■ New Product

Valve Cover Conversion Kit with Flange Safety Device for Spark Plug Leads

For MAN® E32 Gas Engines Series

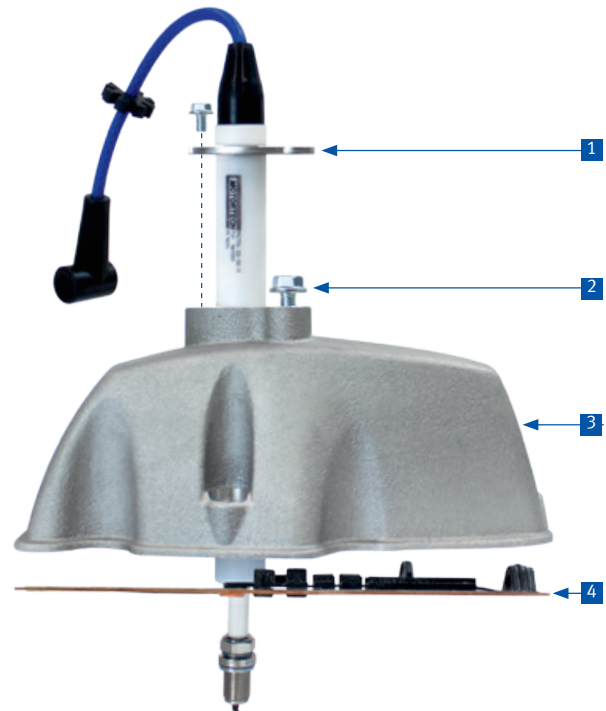
With sales bulletin VM 16 08 I/G (2nd supplement of October 9, 2017) MAN® informed about the valve cover modification for all E32 series engines to lock the spark plug leads. The new safety concept consists of a modified valve cover and two locking devices and therefore needs special spark plug leads. These leads must be equipped with an additional groove, in which the two locking devices can fully engage into in order to fix the spark plug lead on the valve cover.

For recommended retrofitting of already operating engines without safety devices, MOTORTECH also offers an appropriate valve cover conversion kit including all components for an easy conversion:

- 1 Safety flange for spark plug lead
- 2 Hexagon head screws for fixing the flange on the valve cover
- 3 Valve cover with flange support
- 4 Valve cover gasket
